UNITED STATES PATENT AND TRADEMARK OFFICE

10/531,622

Office Action Summary	Application No. 10/531,622	Applicant(s) FOELL ET AL.	
	Examiner M. Safavi	Art Unit 3637

Below find an Office action supplemental to the Office action of May 14, 2008.
The shortened statutory period for response is set to expire three months from the date of this letter.

Attachment: Fig. 16 of Johnson '262

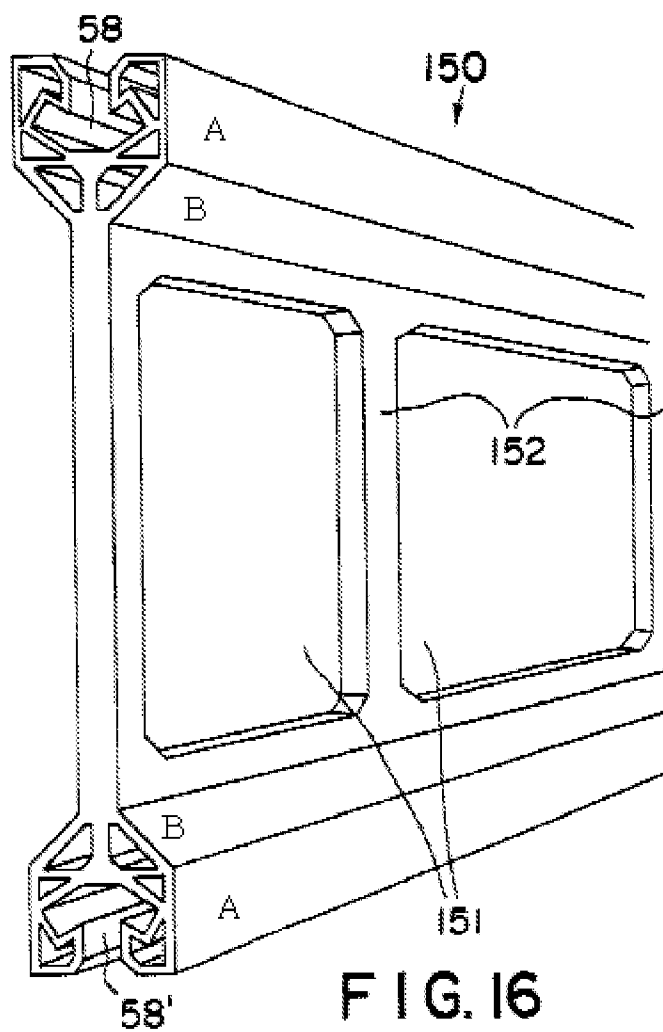
Claims 1, 4, 6, and 8 are rejected under 35 U.S.C. 102(b) as being anticipated by Johnson '262. Johnson discloses, Fig. 16, (see also attached annotated Fig. 16 below), an insert panel 150, wherein the insert panel has one substantially straight or flat surface and wherein the male engagement portions (surrounding 58, 58') at each end extend from a same side of the wall panel, (those engagement portions that surround 58, 58' on the same side of the panel), wherein each male engagement portion has a first projection (A) and an integral second projection (B), wherein the first projections at the ends extend substantially parallel to the wall panel and each other, and wherein the second projections at the ends extend substantially perpendicular to each other.
